World Forum for Harmonization of Vehicle Regulations**Working Party on Lighting and Light-Signalling****Seventy-first session**

**Regulation No. 48 – Proposal for amendments
to the 04, 05 and 06 series of amendments****Proposal for Supplement 14 to the 04 Series of amendments,
Supplement 7 to the 05 Series of amendments and
Supplement 5 to the 06 Series of amendments of Regulation
No. 48****Submitted by the expert from the International Automotive Lighting
and Light Signalling Expert Group***

Decision to Specify Maximum Separation of the Apparent Surfaces

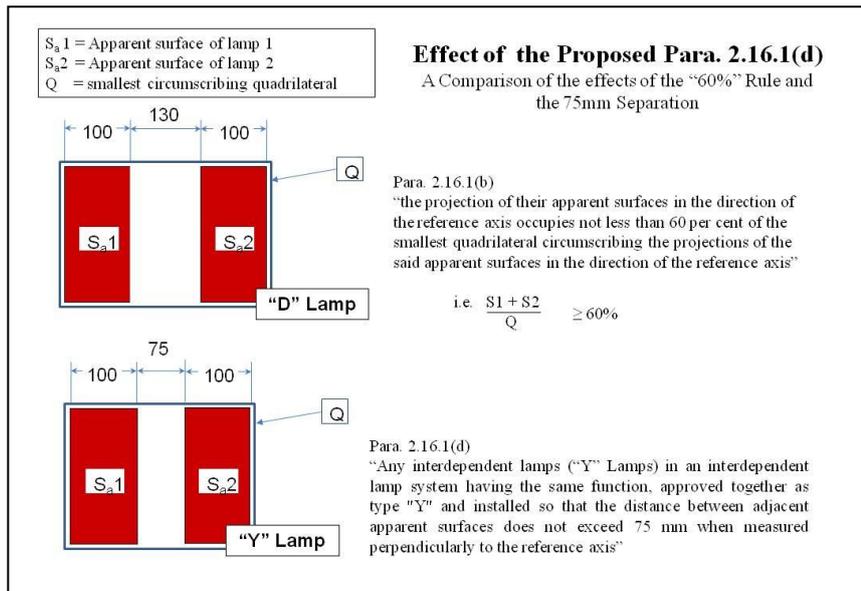
A study commissioned for the AFS Eureka project 1403²² concluded that 2 lamps having a separation of 150 mm are still close enough to be interpreted as one signal.

The 75mm maximum separation has been chosen to ensure a good lit appearance taking into account the two methods allowed to determine the apparent surface in Regulation 48 paragraph 2.10.

The effect of the 75mm separation limit is shown on the following diagram.

GTB concluded that as there is no fundamental difference between the requirements for the lit appearance of lamps marked "D" and lamps marked "Y" the maximum value of 75 mm should be consistently applied to the single lamp.
